Concerned Products:	Customer Notification		Date: Jan. 28, 1998
	Bug Report		NEC-Electronics (Europe) GmbH EAD -Technical Product Support
IE-789026-NS-EM1			Source Doc: SBG-T-0442 SBG-T-0487 SBG-T-0524 SBG-T-0603
			Author: W. Noll M. Kratz
	Jan. 28th, 98	Doc. No.:	TPS-LE-B-ST02
1 st revision:	May 11th, 98	Doc. No.:	TPS-LE-B-ST02
2 nd revision:	June 4th, 98	Doc. No.:	TPS-LEB-ST02

(A) BUG LIST

(B) BUG DESCRIPTION

Figure P50 Block Diagram

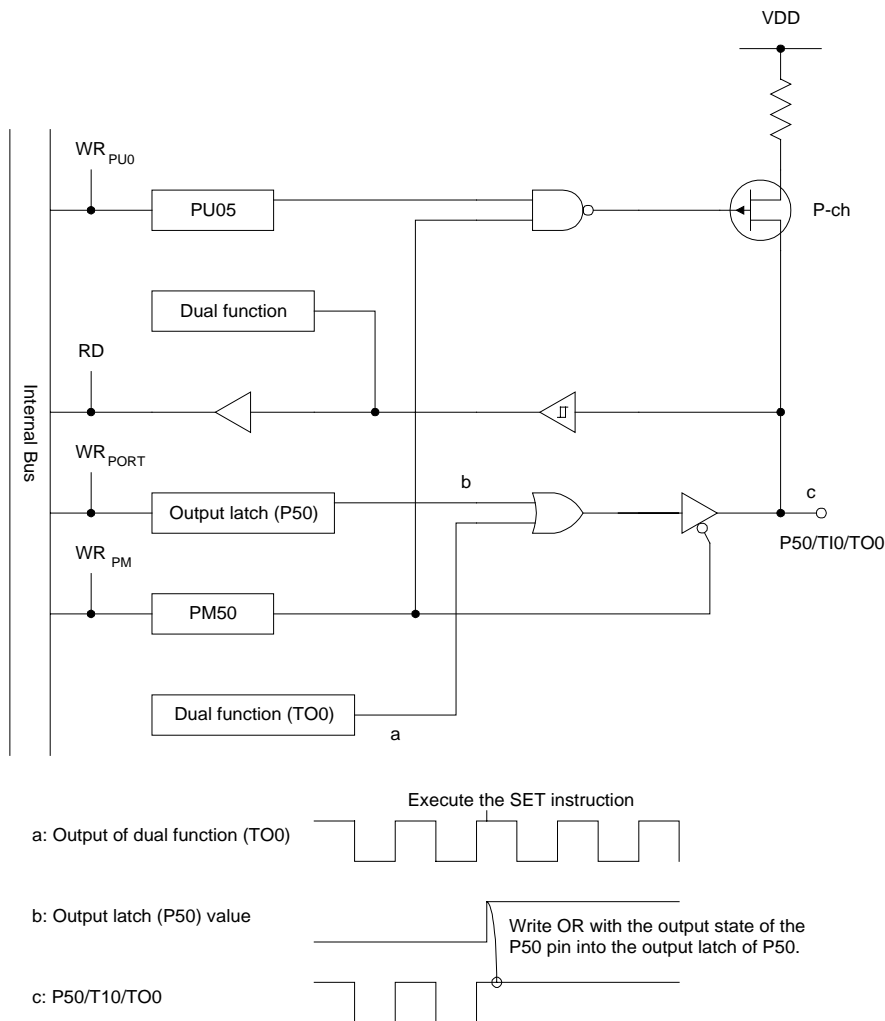
Bug No.	Outline	Description
1	Bit and logical operation at ports 2 and 5	<p>Details</p> <p>Avoid to use bit operation instructions and logical operation instructions on Ports 2 and 5(dual function pins). Instead of this, be sure to use 8 or 16-bit data transfer instructions to control output ports 2 and 5.</p> <p>Reason for operating precautions</p> <p>Executing bit operation instructions (SET1, CLR1) and logical operation instructions (OR, XOR, etc.) on the ports (2 and 5) which have the dual functions of timer output and serial interface may cause the contents of the dual function pins to be different from the expected values. This is because the bit operation instructions and logical operation instructions of the μPD789025, 789026 and 78F9026 are not for performing operations on the contents of the output latch but for performing operations on the status of the relevant pins.</p> <p>We have no plans to change the device circuits.</p> <p>For your reference, Attachment 1 shows an example of executing the SET1 instruction on P52 causing P50 to be fixed to "H" and Attachment 2 is listing the ports and instructions relevant to this precaution.</p>

- ① Uses P50 as the TO0 output to execute "SET1 PORT 5.2" while TO0 is outputting a high level.
- ② The CPU reads all the pin statuses of Port 5 in response to the SET1 operating instruction, sets the relevant bit (P52 in this example) and writes the result to the latch of the Port 5.
- ③ When this SET1 instruction was executed, pin P50 was high level. This results in a high level being written to the output latch of P50, thus causing the pin's output to be fixed to high level. (When outputting TO0, it is necessary to set the output latch to low level first.)
